ORDINANCE NO. <u>2757</u>-79

CPD REZONING

OLENTANGY PLAZA SHOPPING CENTER

DIVISION OF PLANNING REPORT TO THE DEVELOPMENT COMMISSION ON AN APPLICATION TO AMEND THE OFFICIAL ZONING MAP

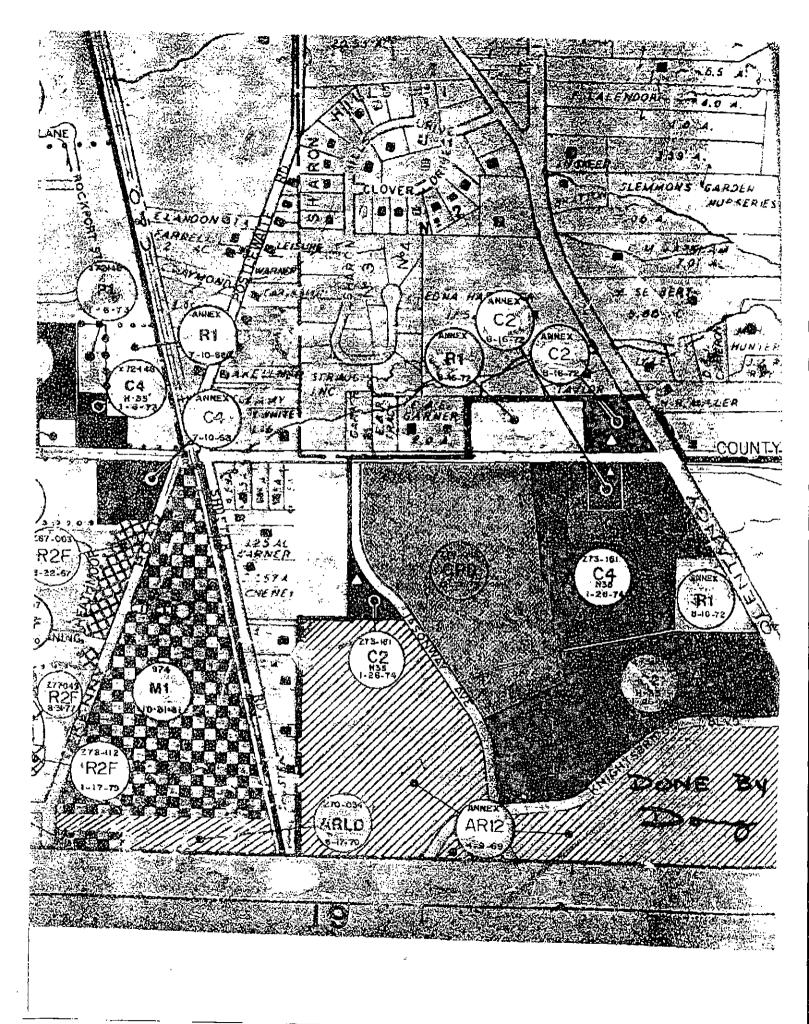
- The signage section in the text should be amended to indicate that a maximum of 2 ground signs would be located on the subject site to identify the shopping center.

- 2). Landscaping along Jasonway Avenue shall consist of heavy evergreen planting on an earth berm (minimum height of the berm to be 2') with a minimum tree height of 5' at installation and a maximum distance between trees of 6 to 7' on center.

- 3) Landscaping along Bethel Road shall consist of treatment of at least 50% of the frontage and consist of a 40' setback which includes an earth berm a minimum of 3' in height landscaped and planted with trees.

- 4) The distance between the landscaped berm along Jasonway Avenue and the major commercial buildings proposed should be increased to permit minimum acceptable loading spaces for delivery trucks (normally 50).

- 5). The layout of the southeastern-most portion of the parking lot should be altered to close the north-south aisle at its southern end, thereby minimizing traffic conflicts and potential hazards.

- 6.) The sections on "Allowable Uses" and "Buildings" in the CPD Text should be amended to read as stated plus "subject to the general site configuration shown on the CPD Map."

- In addition, staff would suggest that the applicant consider the following changes or additions:
 - 1). Realign the main east-west driveway in front of the southern tier of stores to line up with the driveway in front of the existing discount department store to the east.

- 2). Move the southern row of stores northward to align with the building setback line of the existing store to the east.
 - 3). Landscape parking islands, dividers, and end caps with raised curbs and low evergreen plantings, with small trees to be planted in the major islands.
